Environment Agency permitting decisions

Part surrender

We have decided to accept the surrender of part of the permit for The Maltings Organic Treatment Facility operated by The Maltings Organic Treatment Limited.

The permit number is EPR/FP3090SZ

AREA FOR SURRENDER

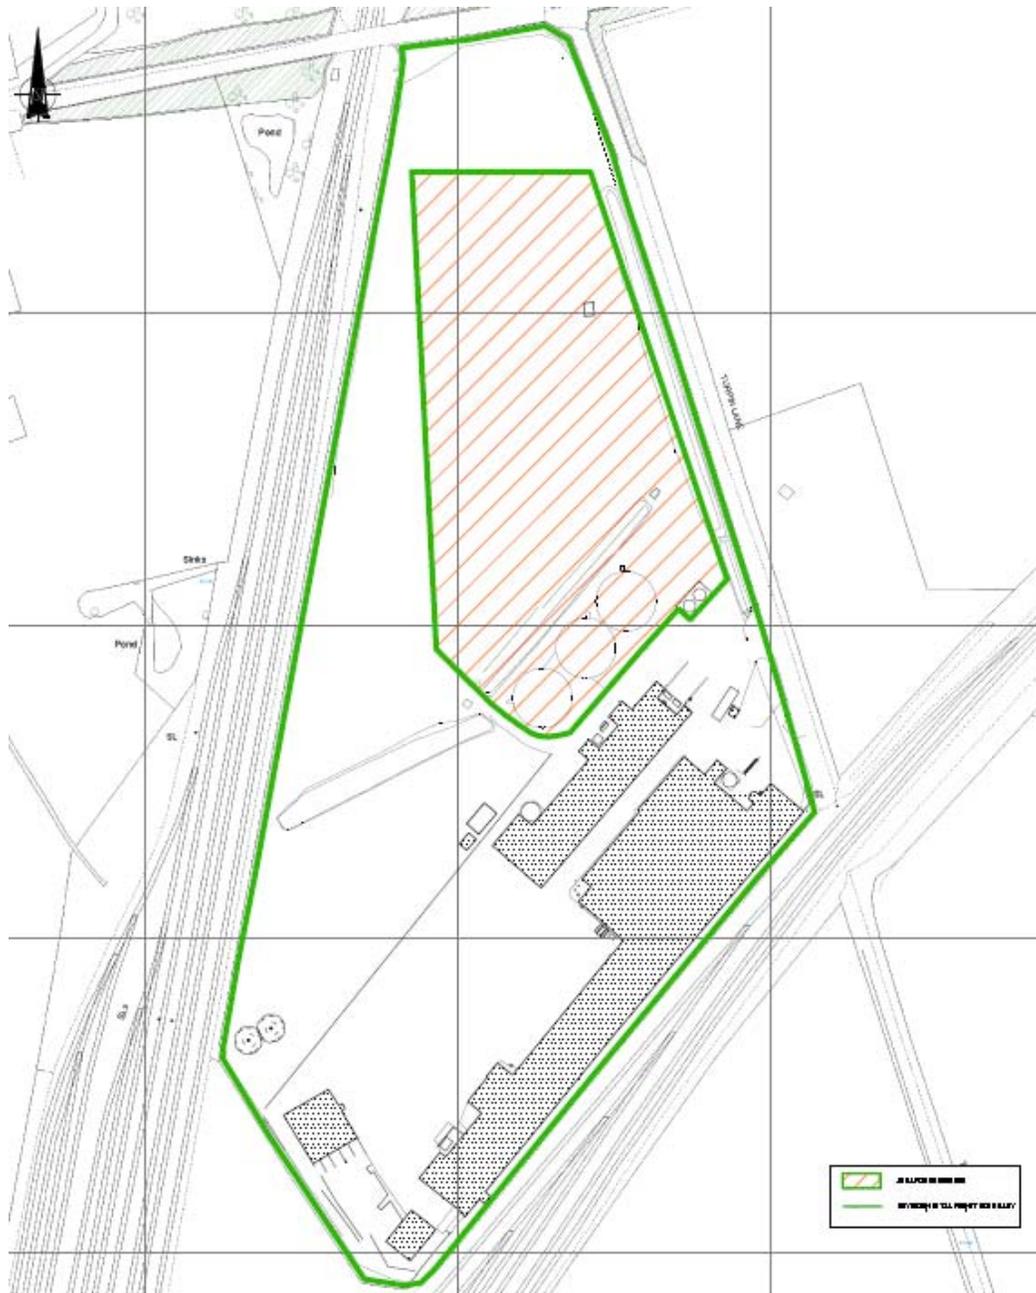
The area being surrendered comprises the eastern section of the 'northern compound' area and an area to its immediate south, see red hatched area on the plan below. These areas had previously comprised concrete surfacing, a strip pond and three circular grain silos, all of which been removed as part of the area's redevelopment. The site plan in Schedule 7 of the permit is amended accordingly.
